UNITED STATES PATENT AND TRADEMARK OFFICE

APPLICATION NO.	FILING DATE	FIRST NAMED INVENTOR	ATTORNEY DOCKET NO.	CONFIRMATION NO.
10/099,645	03/14/2002	Aurelio J. Gutierrez	PENG.617A	2221
27299	7590	11/20/2003	EXAMINER	
GAZDZINSKI & ASSOCIATES 11440 WEST BERNARDO COURT, SUITE 375 SAN DIEGO, CA 92127			TSUKERMAN, LARISA Z	
			ART UNIT	PAPER NUMBER
			2833

Office Action Summary

DETAILED ACTION

Attachment 1

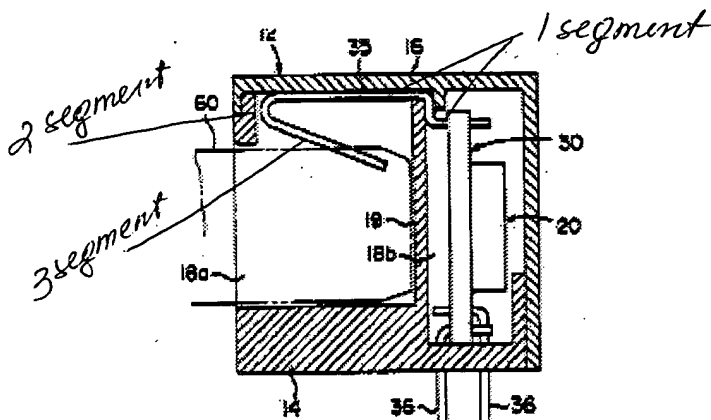
In regard to claim 5, Sakamoto et al. disclose the first conductors 35 comprise at least three conductor segments (see Examiner's Attachment 1), the at least three segments comprising:

- (i) at least a first segment oriented **substantially** normal to the at least one substrate 30;
- (ii) at least a second segment communicating with the at least first segment, the second segment having a substantially different angular orientation with respect to the at least one substrate 30 than the at least first segment; and
- (iii) at least a third segment communicating with the at least second segment, the third segment having a substantially different angular orientation with respect to the at least one substrate than the at least first or second segments.

Attachment 2

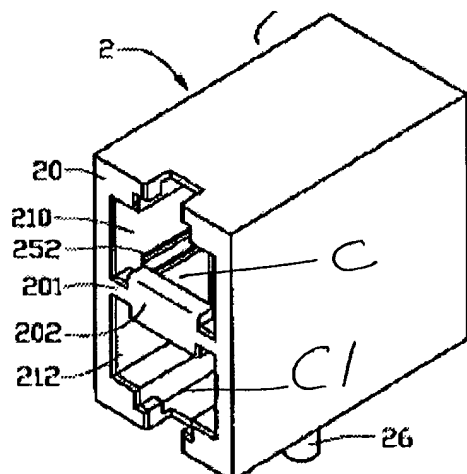
In regard to claims 1, 11, 43 and 45, Wu disclose a multi – port connector assembly (Abstract, line 1) comprising:

a connector **housing** 2 comprising a plurality of connectors C (see Examiner's Attachment 2) having:

a **recess** 210 adapted for receiving at least a portion of a modular plug (not shown, Col. Line), the modular plug having a plurality of terminals disposed thereon (not shown);

at least one **substrate** (PCB) 7 having at least one electrically conductive **pathway** associated therewith;

a **cavity** 22 adapted for receiving at least a portion of the at least one substrate, the at least one substrate being disposed within the cavity in substantially

orthogonal orientation (see Fig. 1) with respect to a front face of the housing;

a plurality of **first conductors** 4 disposed at least partly within the recess, the first conductor being configured to form an electrical contact with respective ones of the terminals when the modular plug is received within the recess, and for forming an electrical pathway between the first conductor and the at least one substrate 7; and

a **plurality of second conductors** 61, at least one of the second conductors being in electrical communication with the at least one electrically conductive pathway of the at least one substrate.

In regard to claim 23, Wu discloses at least two of the connectors C and C1 are disposed in a port pair (see Examiner's Attachment 2 and Abstract), the first conductors 4 of each connector in the port pair being substantially coplanar, the plane of the first conductors of a first connector in the port pair being substantially parallel with that of the first conductors of a second connector in the port pair.
